DART AEROSPACE LTD	Work Order: 01325
Description: Crosstube Assembly (205/212/412 High Fwd)	Part Number: D212-664-141
Inspection Dwg: D212-664-141 Rev: D	Page 1 of 1

DRAWING NO. D212-664-141		REV. D SHEET 1 OF 4	
TITLE XTUBE ASS'Y (205/212/412 HI FWD)		SCALE NTS	
COPYRIGHT © 2000 BY DART AEROSPACE LTD THIS DOCUMENT IS PRIVATE AND CONFIDENTIAL, AND IS SUPPLIED ON THE EXPRESS CONDITION THAT IT IS NOT TO BE USED FOR ANY PURPOSE OR COPIED OR COMMUNICATED TO ANY OTHER PERSON WITHOUT WRITTEN PERMISSION FROM DART AEROSPACE LTD.

DRAWING NO. D212-664-141	TITLE XTUBE ASSY (205/212/412 HI FWD)	REV. D	DART AEROSPACE LTD ENGINEERING ORDER		D.E.O. NO. D212-664-141-D-1	SHEET NO. SHEET 1 OF 2	SCALE NTS
DRAWN	CHECKED	MFG. APPR.	APPROVED	DE APPR.			
DATE 11.04.07	DATE 11.04.11	DATE 11.04.12	DATE 11/04/12	DATE 11.04.12

DRAWING NO. D212-664-141	TITLE CROSSTUBE ASS'Y (205 HI FWD)	REV. D	DART AEROSPACE LTD ENGINEERING ORDER		D.E.O. NO. D212-664-141-D-2	SHEET NO. SHEET 1 OF 1	SCALE NTS
DRAWN <i>UP</i>	CHECKED <i>ASS</i>	MFG. APPR. <i>AS</i>	APPROVED <i>MD</i>	DE APPR. <i>HA</i>			
DATE 11.07.15	DATE 11.07.20	DATE 11.07.21	DATE 11/07/21	DATE 11.07.21

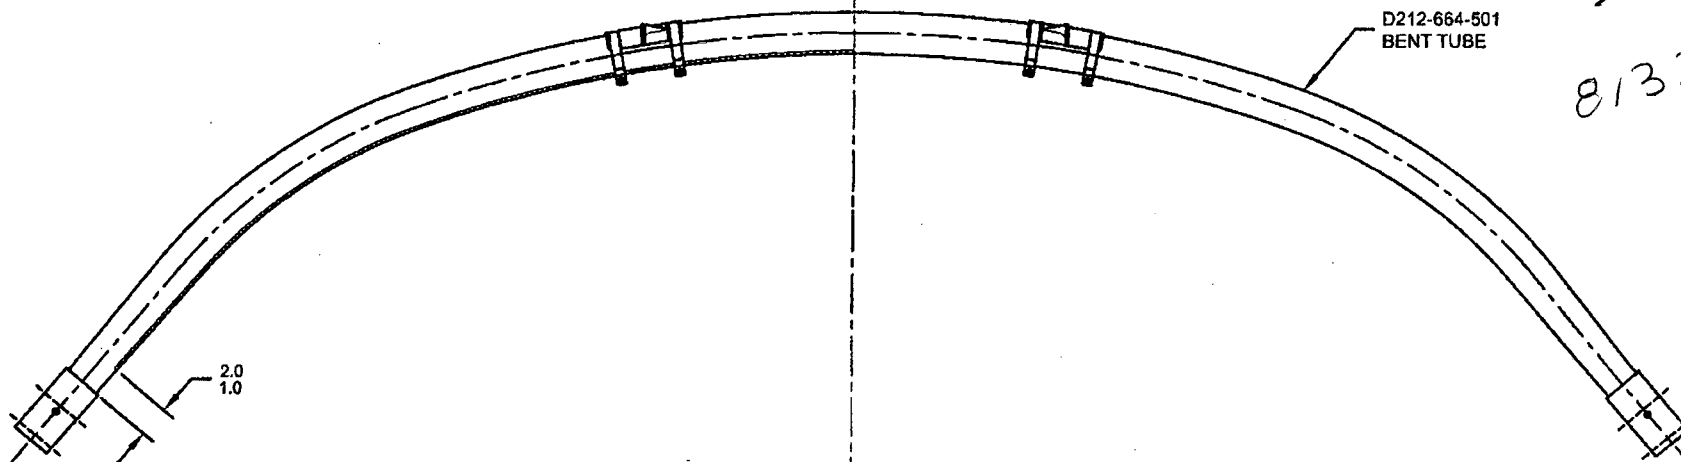
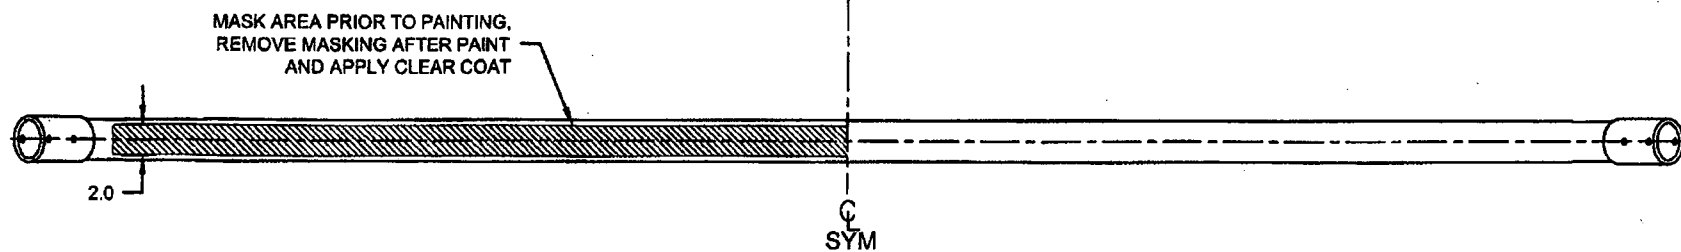
PURPOSE:

ADD AN INSPECTION WINDOW TO UNDERSIDE OF CROSSTUBE.

NOTES 2 OF SHEET 1 IS AMENDED AS FOLLOWS:

- 2) FINISH: CHEMICAL CONVERSION COAT PER DART QSI 005 4.1
PRIME INSIDE AND OUTSIDE PER DART QSI 005 4.2
MASK UNDERSIDE OF CROSSTUBE AS SHOWN (HATCHED AREA) AND
PAINT OUTSIDE PER DART QSI 005 4.2
REMOVE MASKING AND APPLY CLEAR COAT
